COPPERSTRING EIS

Attachment F - Vegetation Clearing Works plans

Dajarra Road to Mount Isa

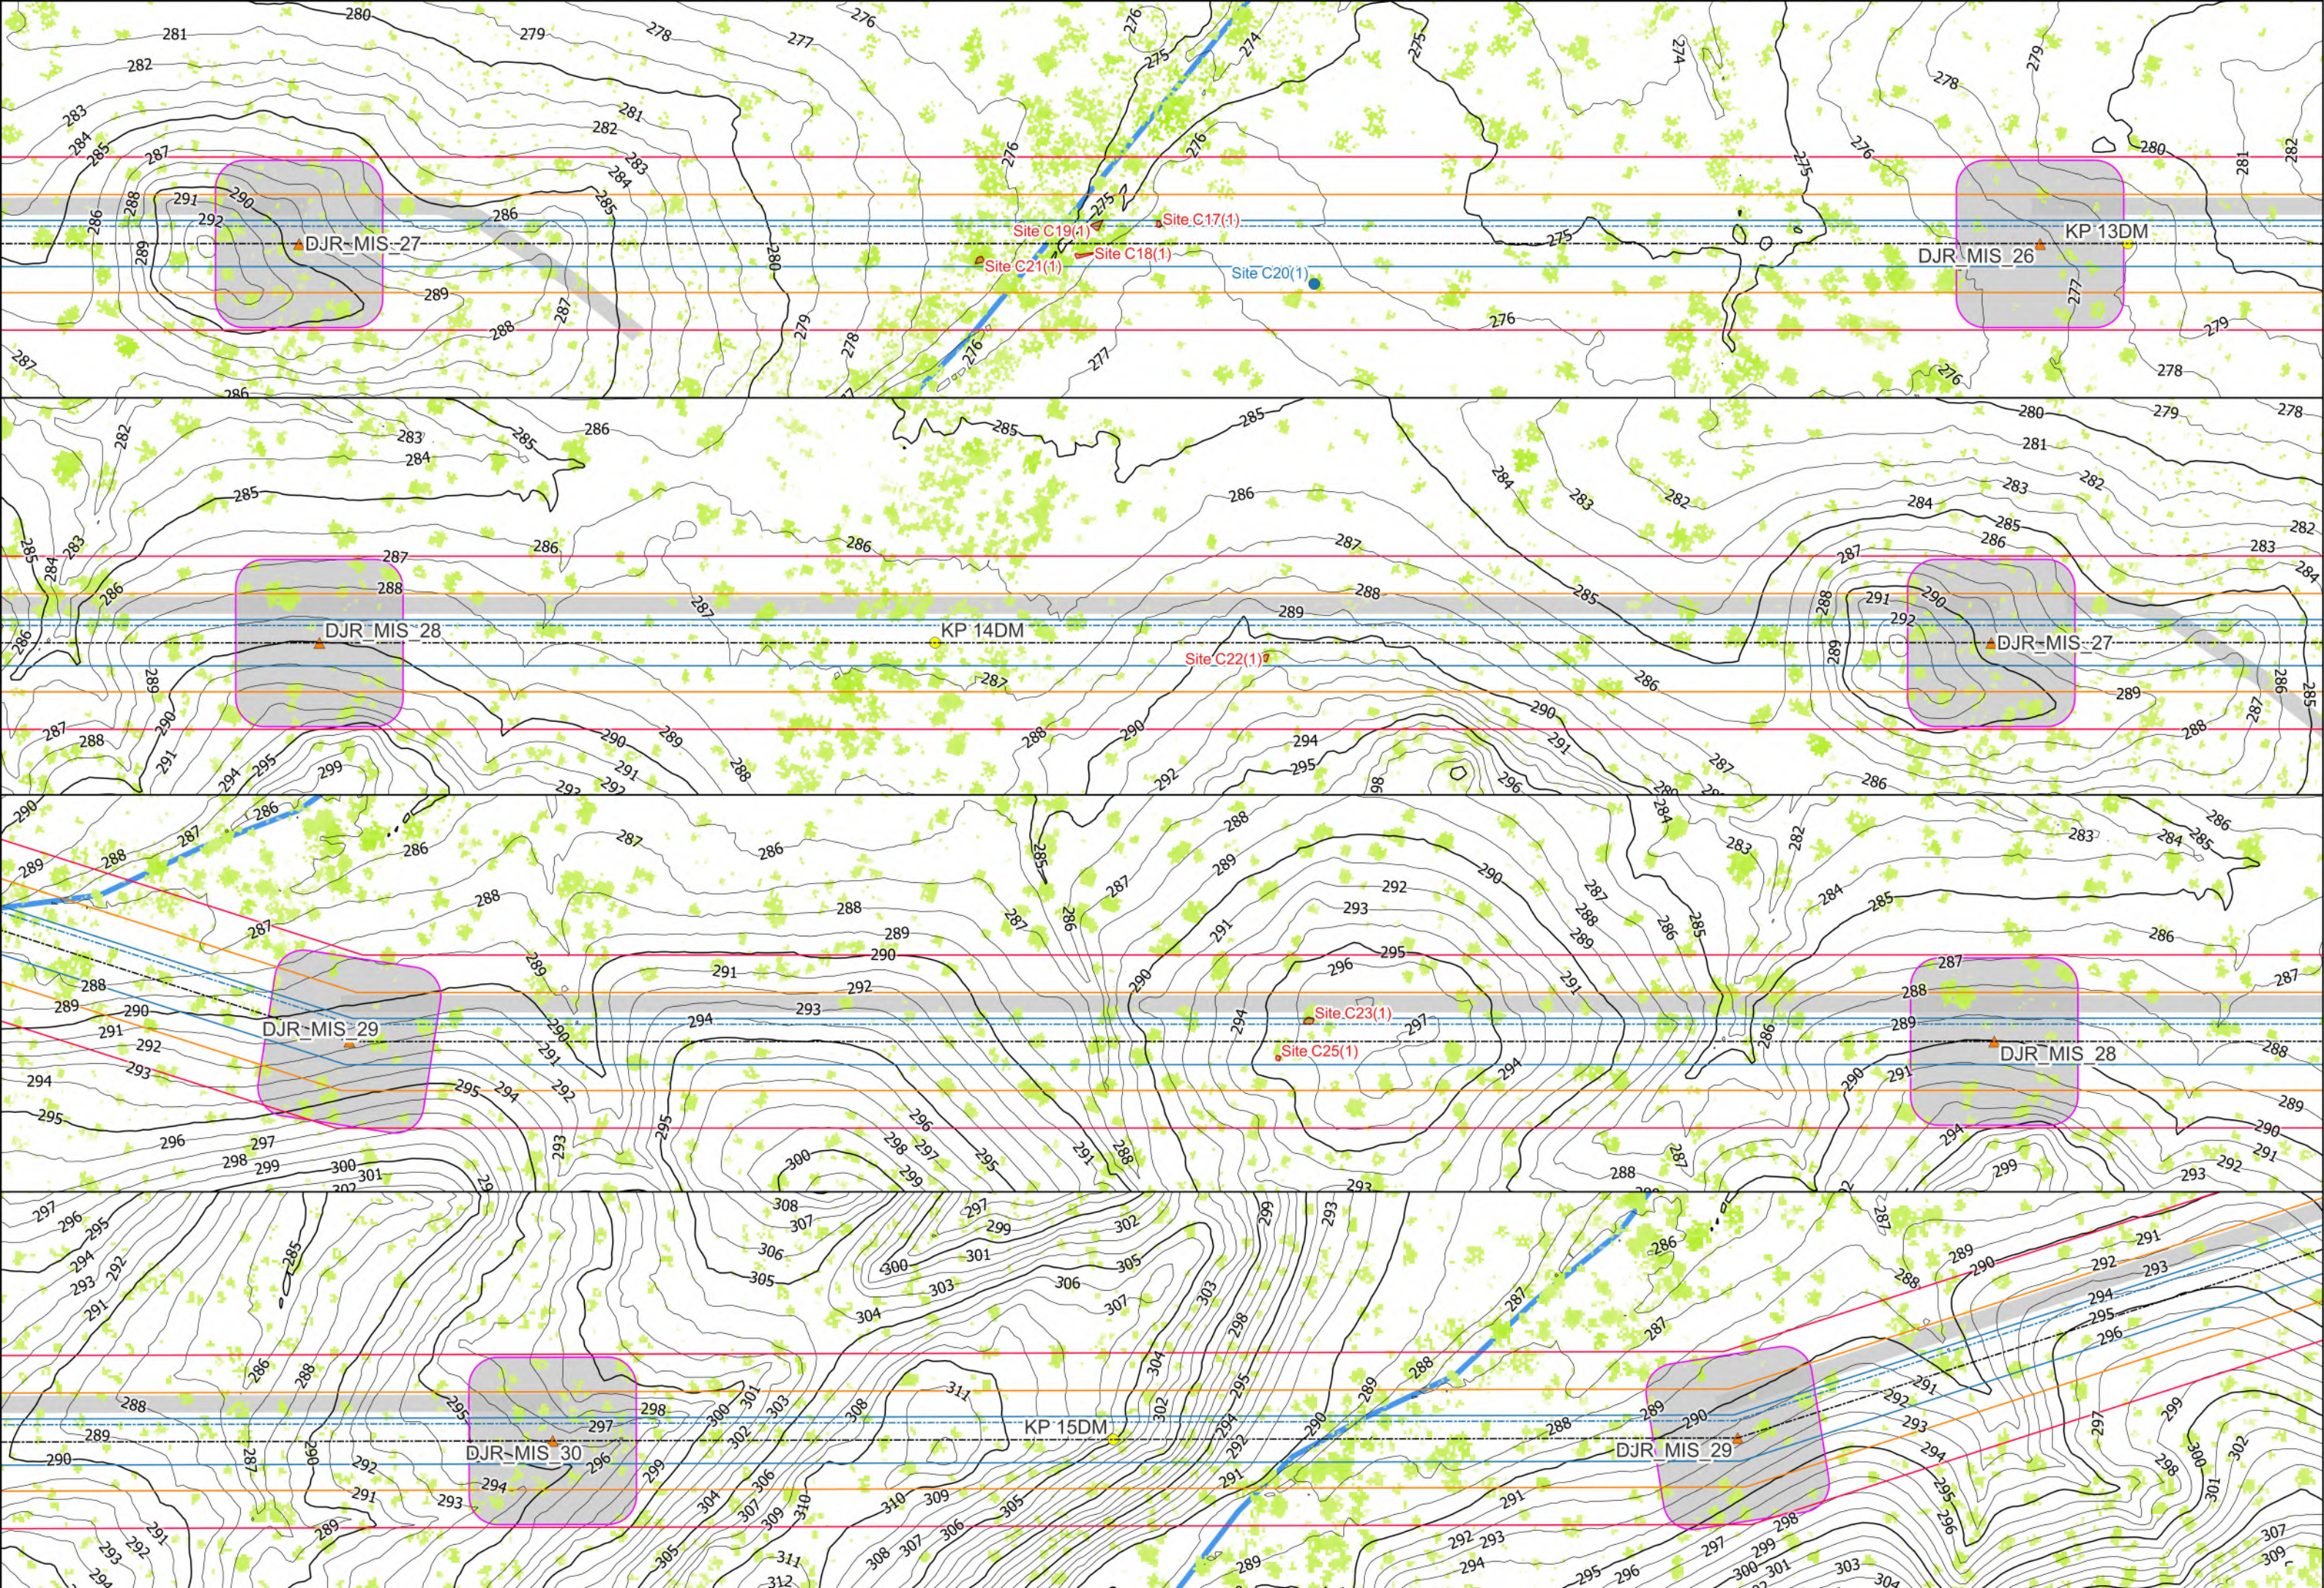
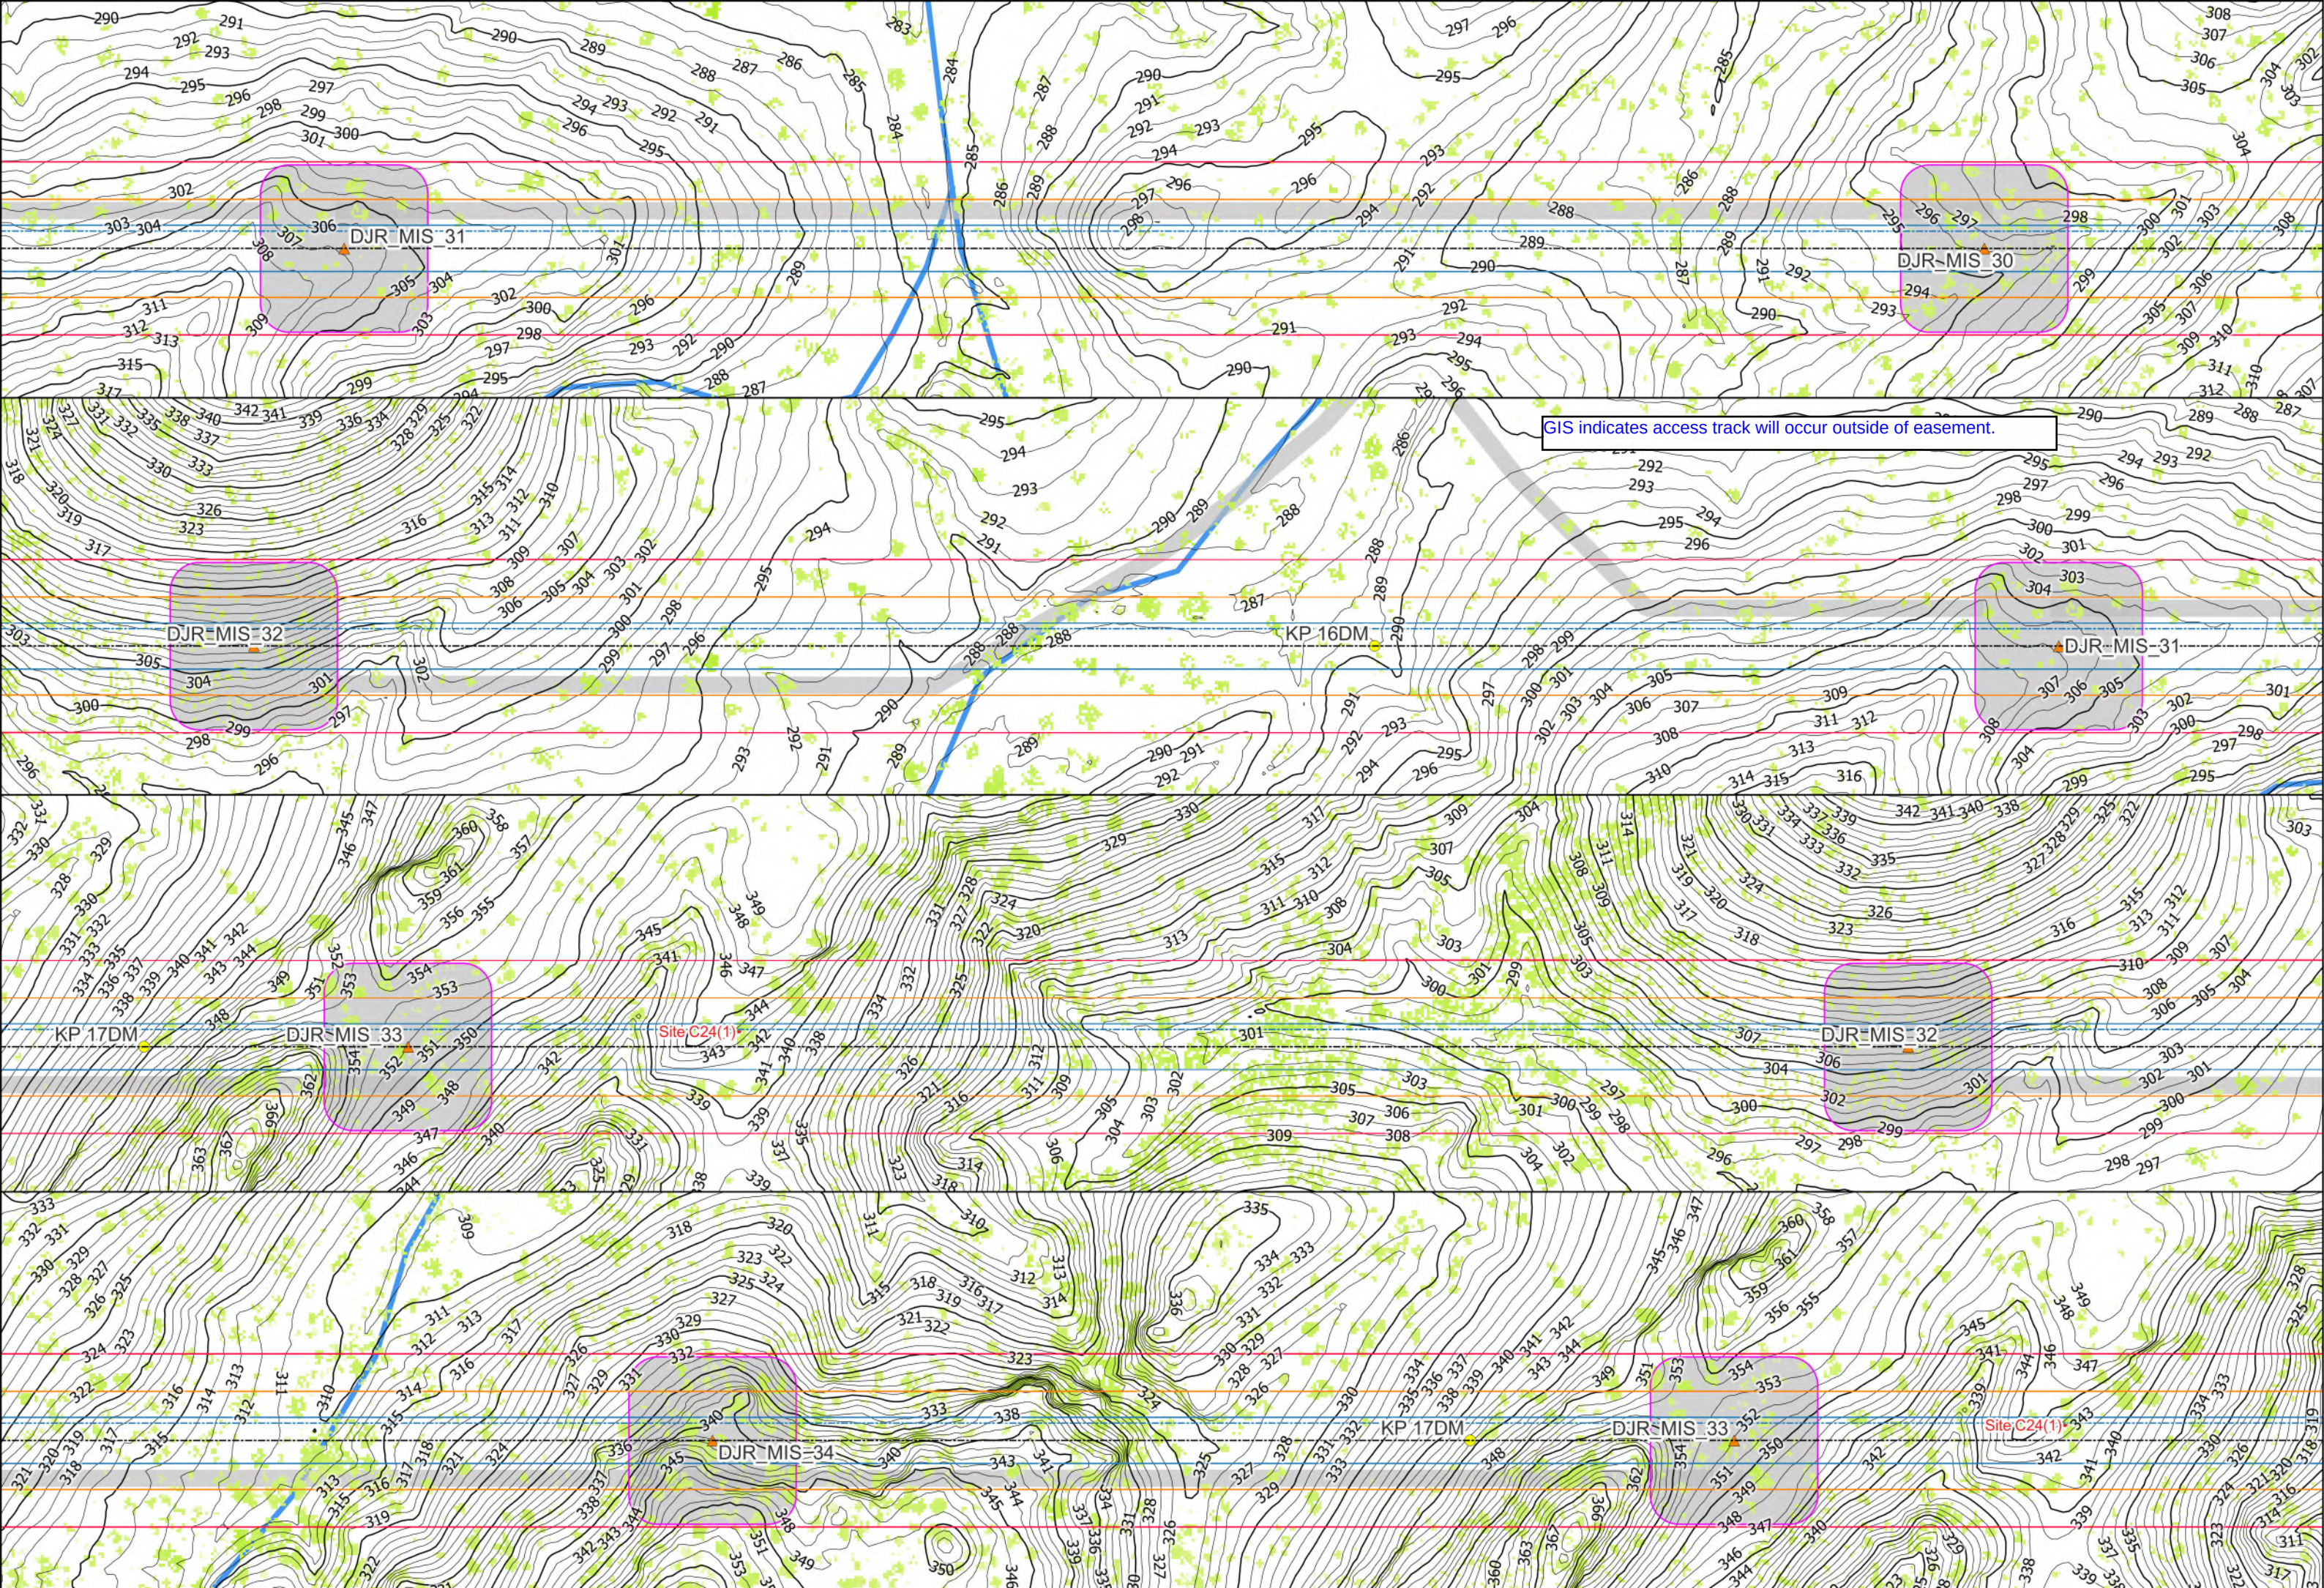
GIS indicates access track will occur outside of easement due to large changes in topography.

GIS indicates access track directly between towers. However, changes in topography may require variations to access track route design.
